Strathfield Local Planning Panel Meeting

Thursday, 3 March 2022

TO: Strathfield Local Planning Panel Meeting - 3 March 2022
REPORT: SLPP – Report No. 5
SUBJECT: S8.2-DA2021.151- 20 WENTWORTH STREET GREENACRE
 LOT 4 DP 36122
DA NO. S8.2-DA2021.151

Proposal:	Section 8.2 Review of DA2021/151- Demolition of existing structures and construction of a dual occupancy with basement.
Applicant:	ZTA Group
Owner:	R Ibrahim & J Ibrahim
Date of lodgement:	6 December 2021
Notification period:	10 December 2021 – 10 January 2021
Submissions received:	Nil
Assessment officer:	L. Gibson
Estimated cost of works:	\$992,903.00
Zoning:	R2-Low Density Residential - SLEP 2012
Heritage:	No
Flood affected:	Yes
Is a Clause 4.6 variation proposed?	No
RECOMMENDATION OF OFFICER:	APPROVAL

Figure 12: Shadow diagrams of proposed development

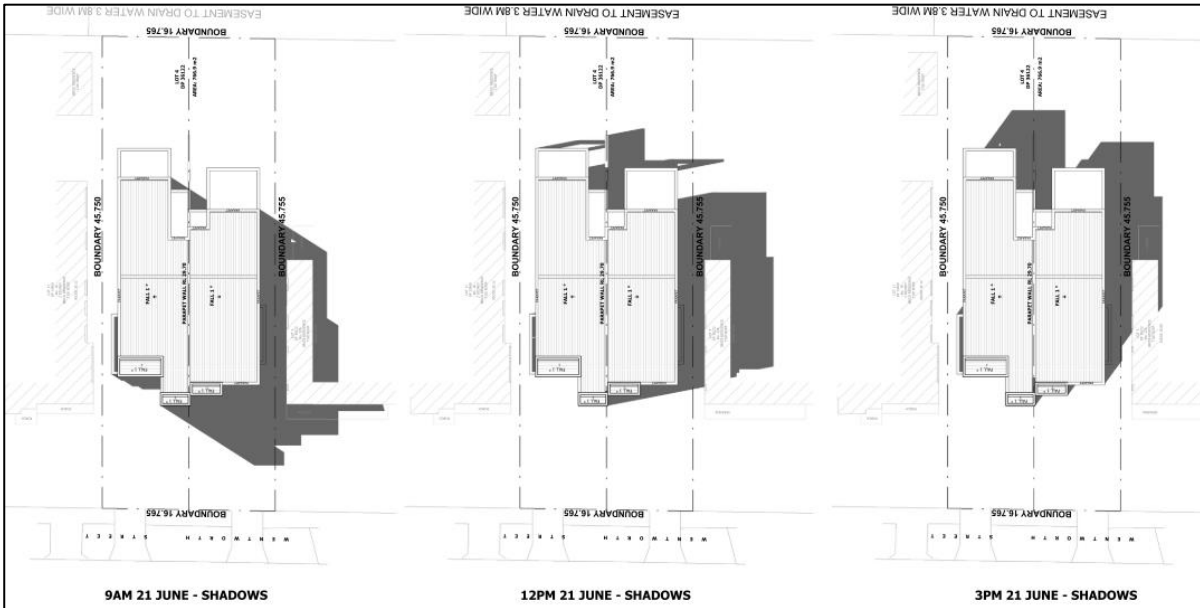
A series of revised shadow diagrams were submitted to Council during the assessment process to demonstrate the impact of overshadowing to the southern adjoining property. The site is oriented east-west and overshadowing is therefore inevitable. The shadow moves east during the day demonstrating that the front portion of the southern adjoining dwelling and 2 north-facing windows will receive direct solar access from 3pm onwards. The diagrams also demonstrate that whilst the new development will result in overshadowing to the southern adjoining property, solar access will still continue to be provided to most of the front and rear yards of the adjoining site throughout the day. The proposal is therefore acceptable in this regard.

Figure 12. Illustration of a vehicle entering the basement in a forward direction and then reversing into the allocated north-western parking space.

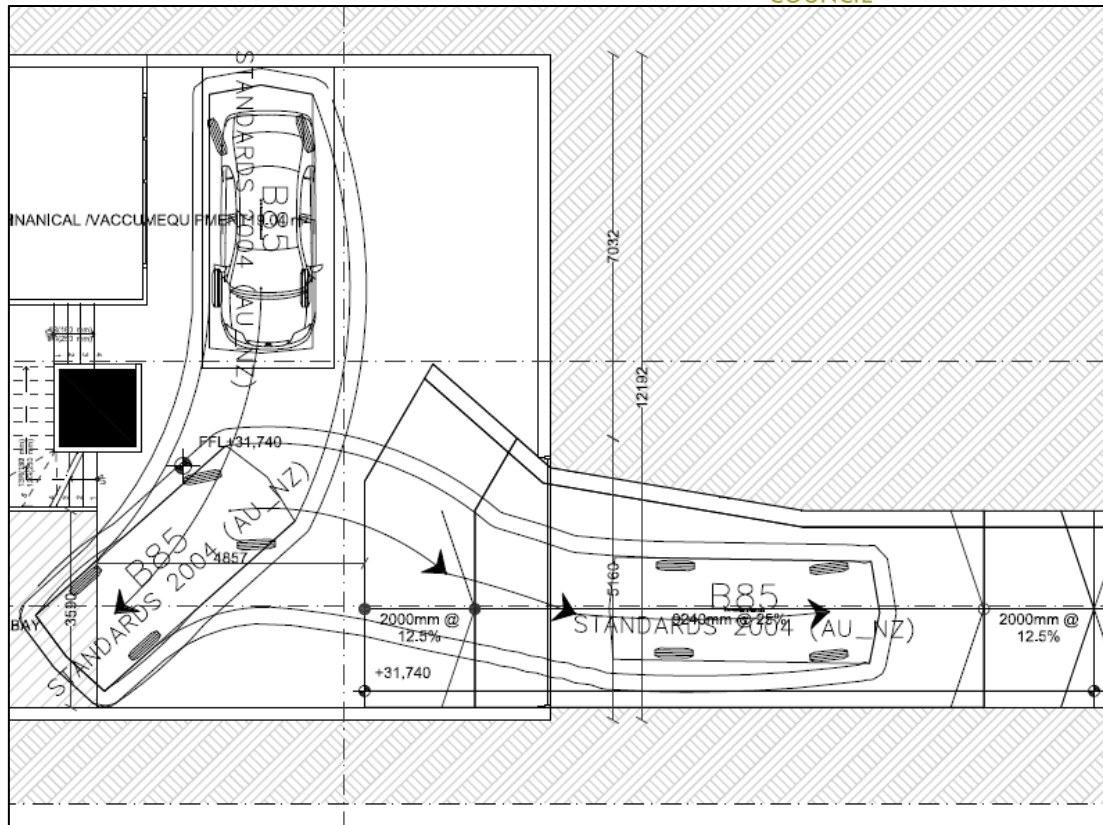
The proposed development involves two parking spaces situated within the 'basement'. Based on the proposed layout of the basement, there is insufficient room to enable each car to manoeuvre within this level and safely enter and exit the site in a forward direction. A swept paths illustration was provided to Council as part of application demonstrating that the vehicles will be able to enter and exit in a forward direction and satisfy the Australian Standards.

The provided swept paths, in particular the one shown in Figure 13 below, demonstrate that the proposed layout of the basement is incapable to satisfy the requirement of Council for vehicles to enter and exit the site in a forward direction.

Figure 13. Illustration of a vehicle exiting the basement in a forward direction with the swept paths encroaching onto the other car's parking space.

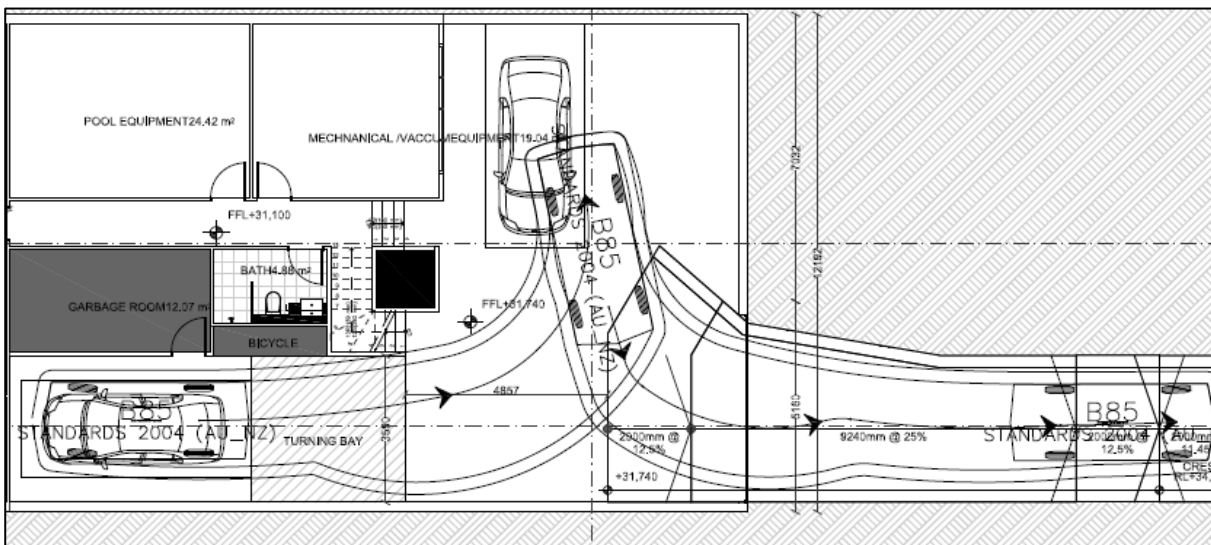
The proposal is not supportable and the application is recommended to be refused.
